SERVICE BULLETIN

M-991

1340 CLUTCH INFORMATION FOR 1990 MODELS

Figure 1. Clutch Release Components

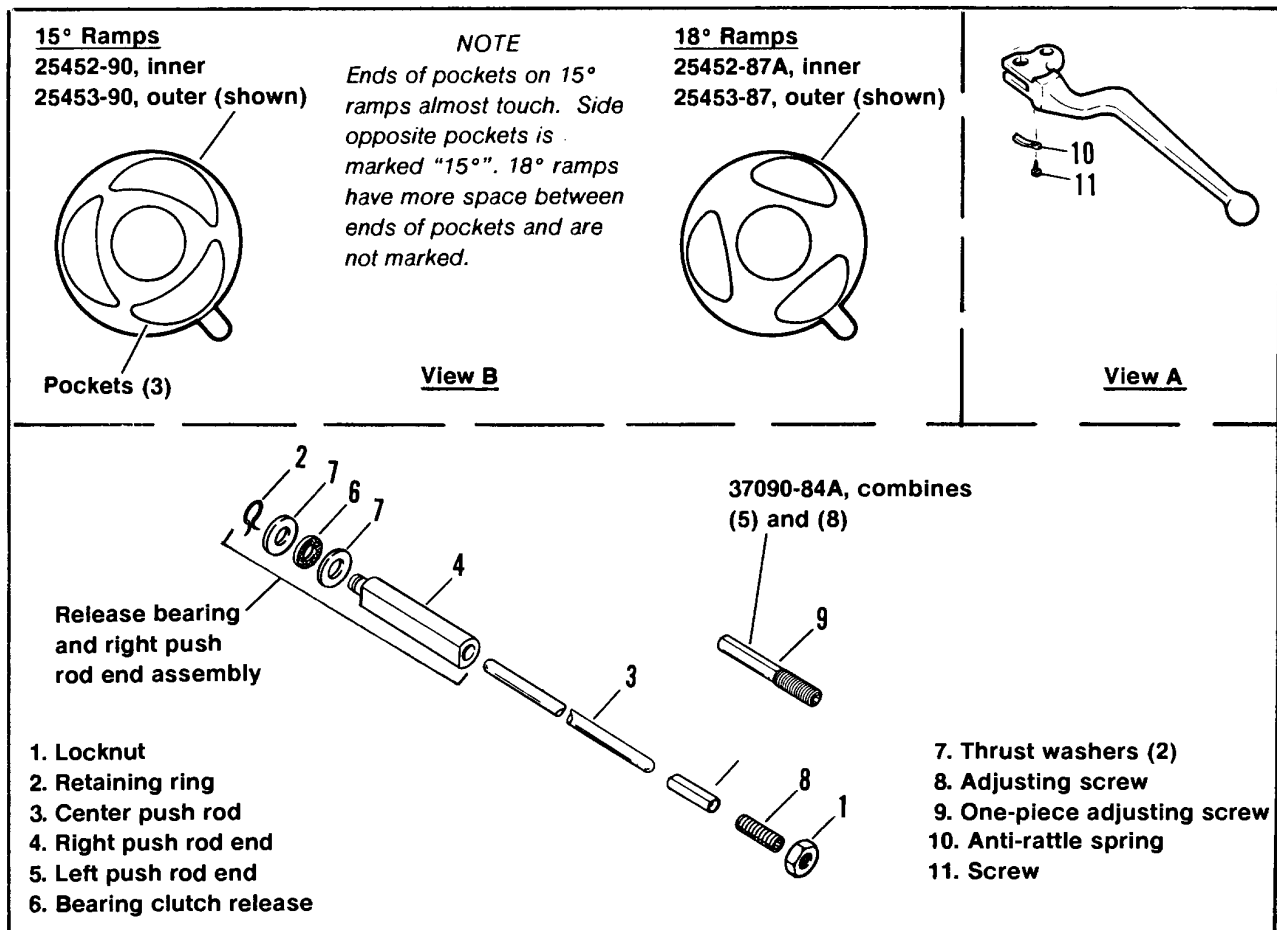
See Figure 1. The left push rod end, Part No. 37090-84 and adjusting screw, Part No. 37357-84 have been replaced by a single item Part No. 37090-84A. This change reduces the possibility of clutch drag by decreasing any tendency for the clutch pressure plate to tip. This change was made to production vehicles in December, 1989.

See Figure 1, View B. Beginning **March 28, 1990**, **transmission number 90087042**, clutch release ramps, Part No. 25452-87A (inner) and 25453-87 (outer) will be used in production. These ramps will provide more movement (lift) to the push rod to further reduce the possibility of clutch drag. This change will slightly increase clutch lever effort.

See Figure 1, View A. During the installation of the one-piece adjusting screw and earlier release ramps, remove the anti-rattle spring (10) and its' retaining screw (11). The spring may affect free-play in the clutch lever and could cause the clutch throw-out bearing to be slightly loaded. That loading could cause premature failure of the throw-out bearing.

3. See Figure 1. With a magnet, remove the left push rod end (1).
4. Install new one-piece adjusting screw into release plate and install locknut (2) on adjusting screw. **DO NOT ADJUST PUSH ROD NOW**, adjust after release ramps have been installed.

1. Refer to pages 7-30 and 7-31 in the 1985 TO 1990 FX/SOFTAIL MODELS Service Manual, Part No. 99482-90 for instruction on removing release ramps and installing the earlier ramps. See Figure 1, View B for identification of release ramps.
2. See Figure 1. After transmission side cover has been removed, remove the clutch release bearing and push rod assembly and center push rod (3). Install a new release bearing if excessive wear or overheating of bearing is evident. Also inspect the center push rod (3) for wear or damage. Install new push rod parts if required.

Figure 2. Push Rod Adjustment

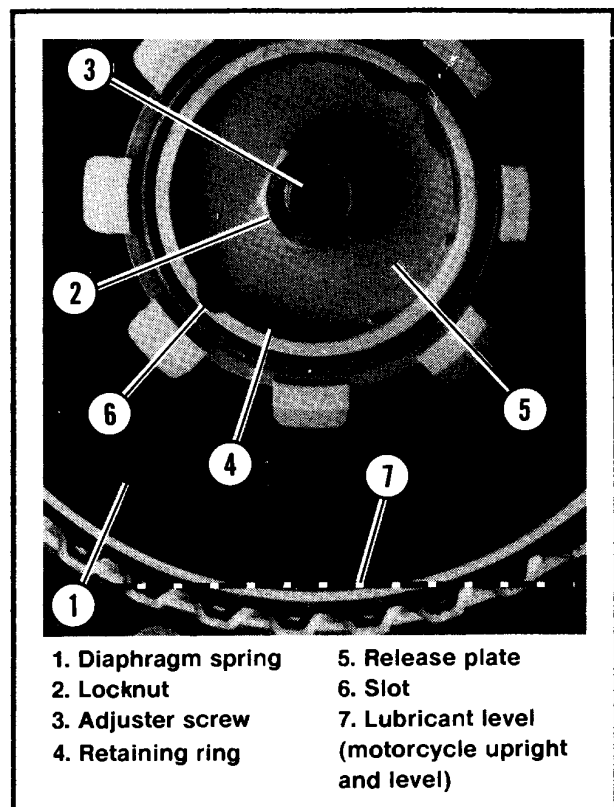
1. Loosen clutch cable and remove the clutch inspection cover.
2. See Figure 2. Loosen locknut (2) and unthread adjuster screw (3) from release plate (5).

3. See Figure 2. After transmission side cover has been installed, fill the transmission with lubricant to the full mark on dipstick with dipstick resting in place (not threaded into side cover). Adjust clutch push rod by lightly bottoming adjuster screw (3) and then backing screw out 1/2 - 3/4 turn. Hold screw with allen wrench and tighten locknut (2) to 6-10 ft-lbs torque.
